Appendix D

Common Boundary Rehabilitation Plan Landform

MTO / BCC Boundary Area

Section E

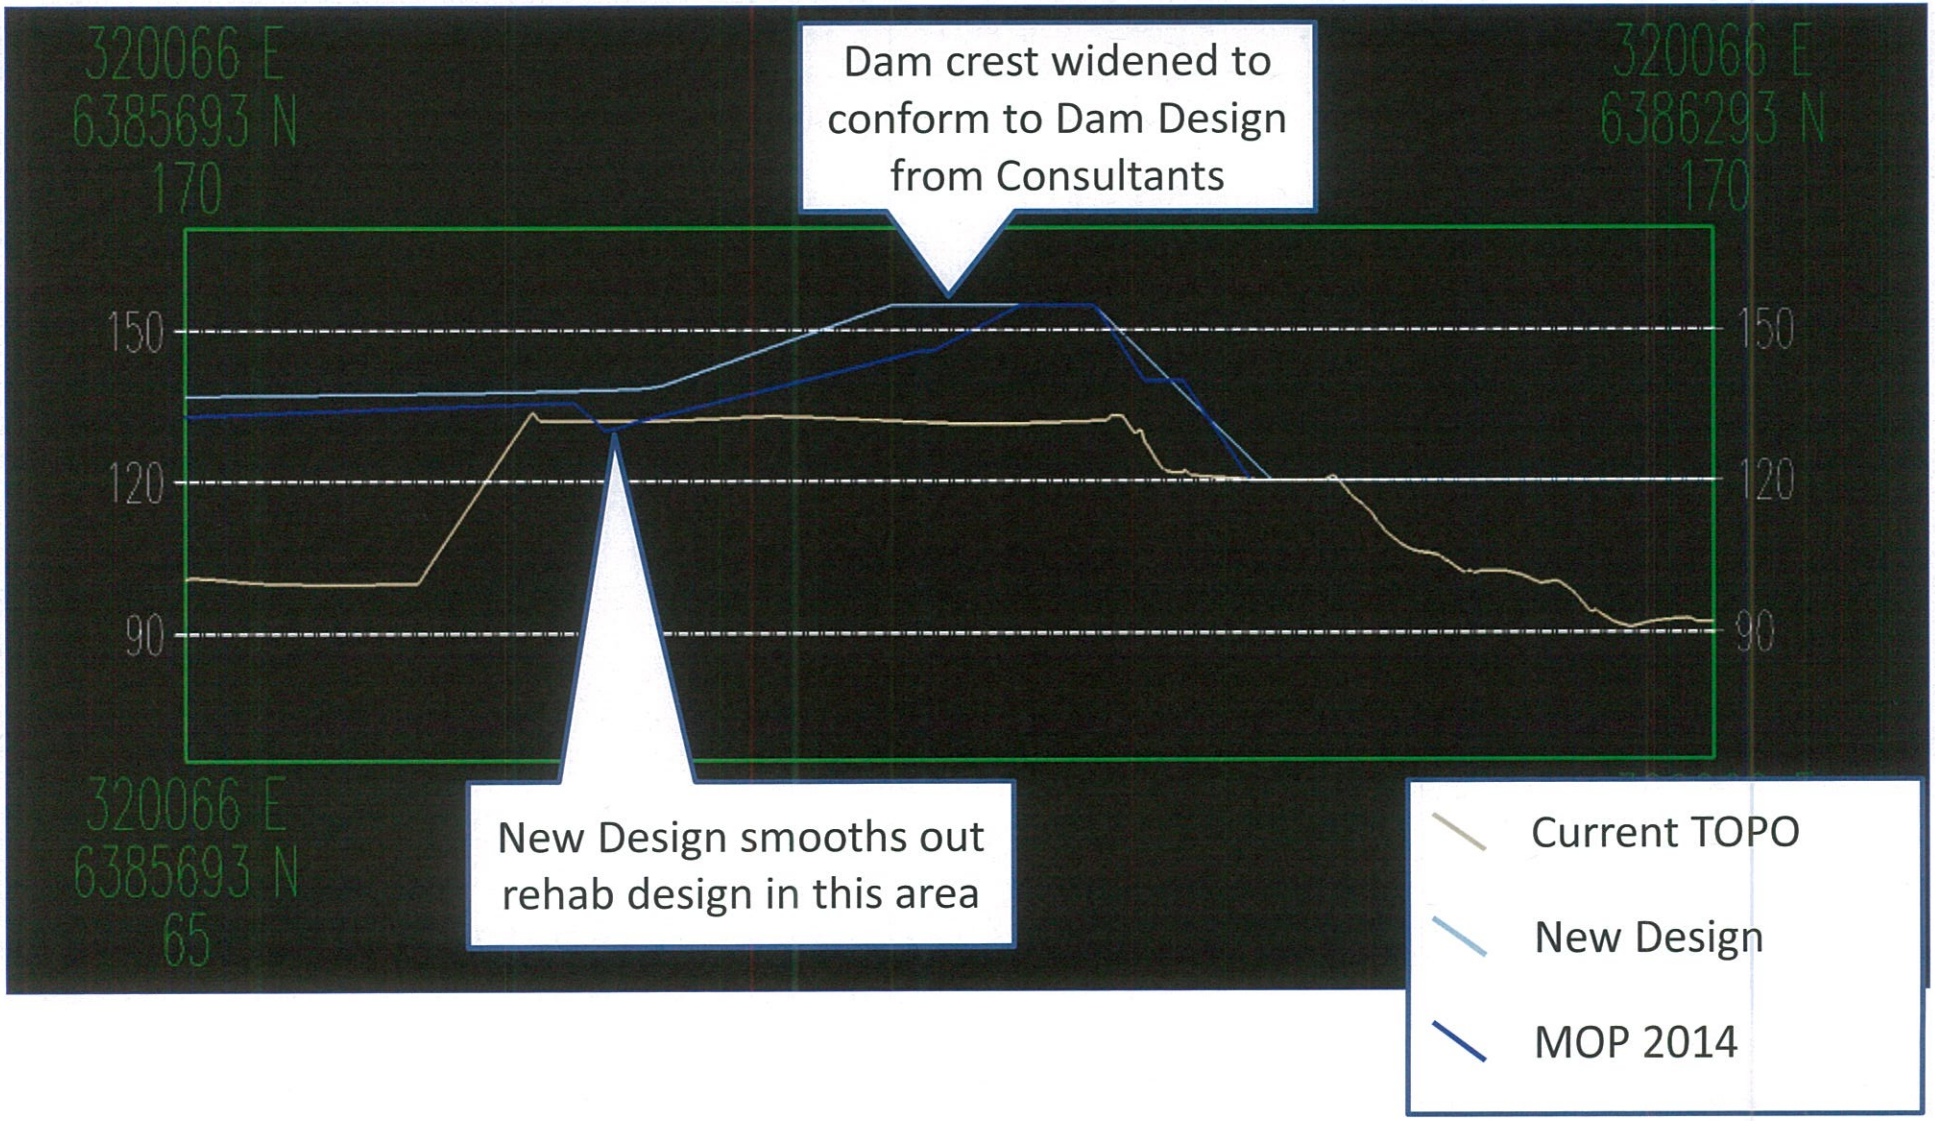
320066 E
6385693 N
170
320066 E
6386293 N
170
Dam crest widened to conform to Dam Design from Consultants
150
120
90
150
120
90
320066 E
6385693 N
65
New Design smooths out rehab design in this area
Current TOPO
New Design
MOP 2014

Analysis Area

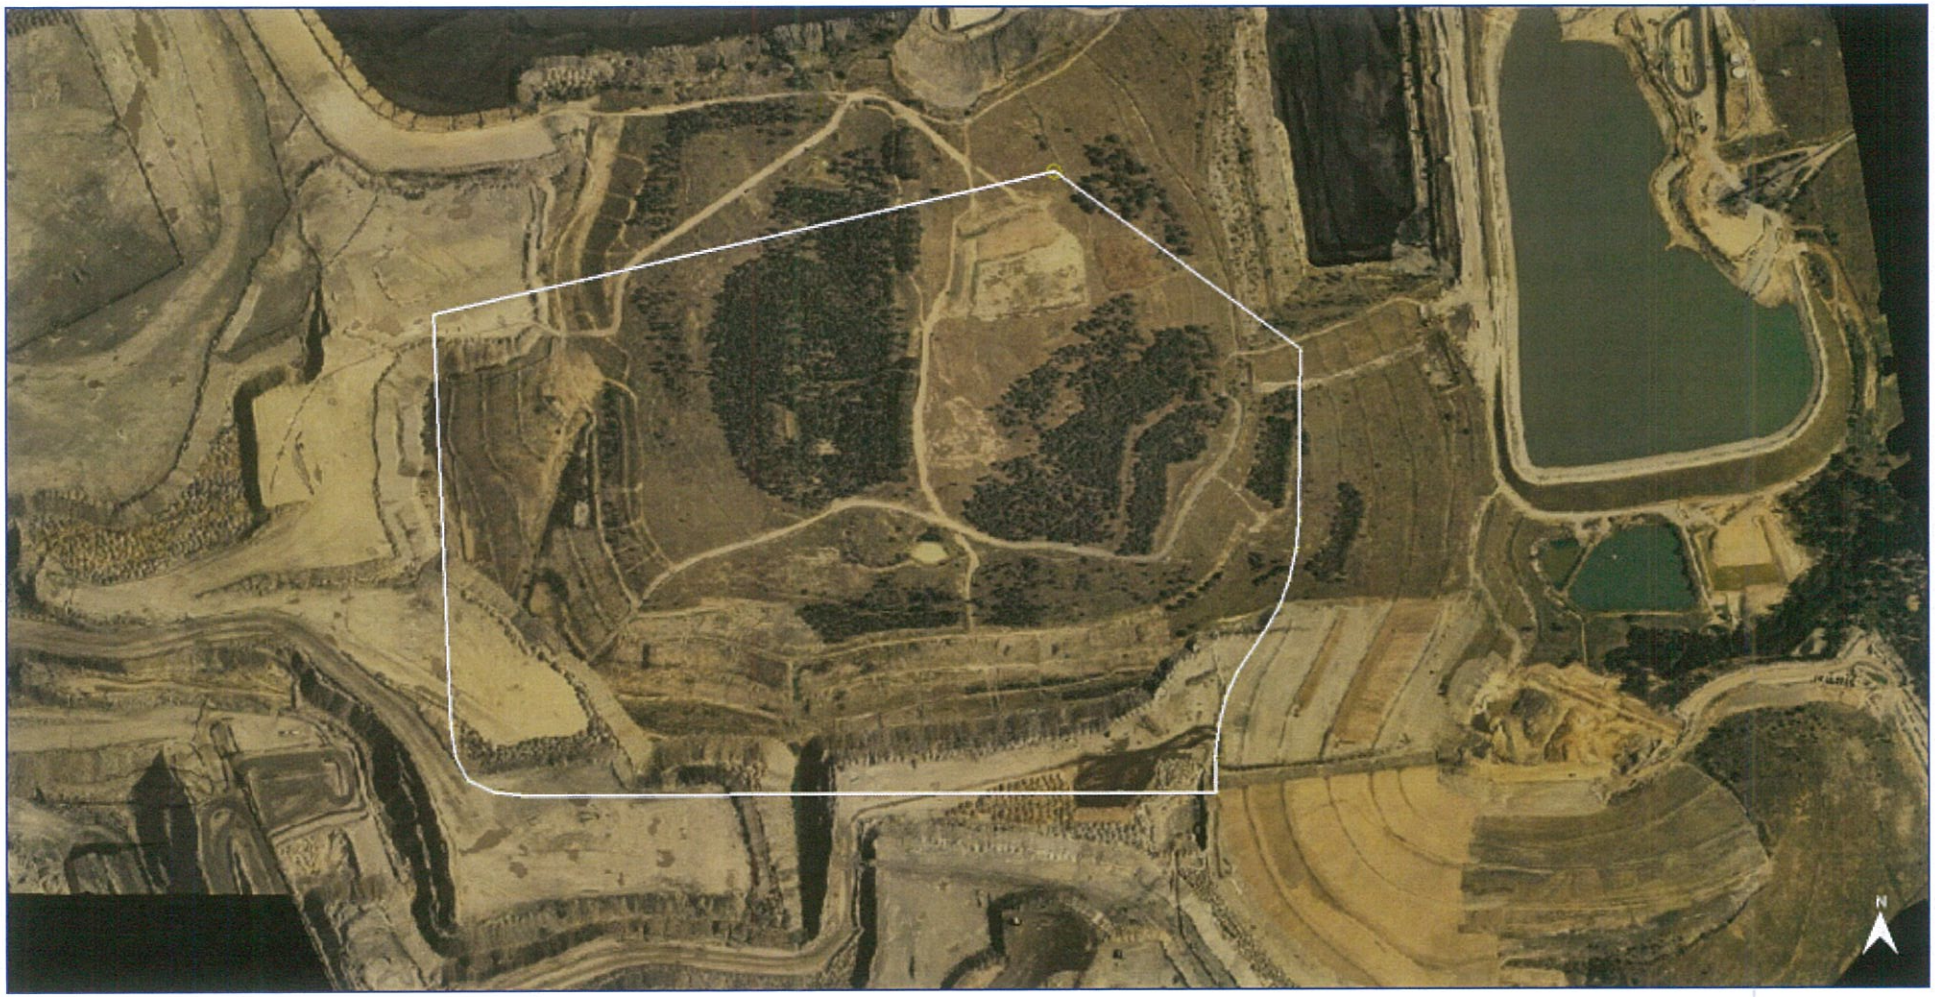
MOP 2014
Fill Required = 12,074,000 BCM (15,092,500 LCM)
Area Effected = 71.1 Hectares

New Design
Fill Required = 4,770,000 BCM (5,962,000 LCM)
Area Effected = 44.93 Hectares

Net Change in Fill = **-7,304,000 BCM** (-9,130,500 LCM)
Change in Area = **-26.17 Hectares**
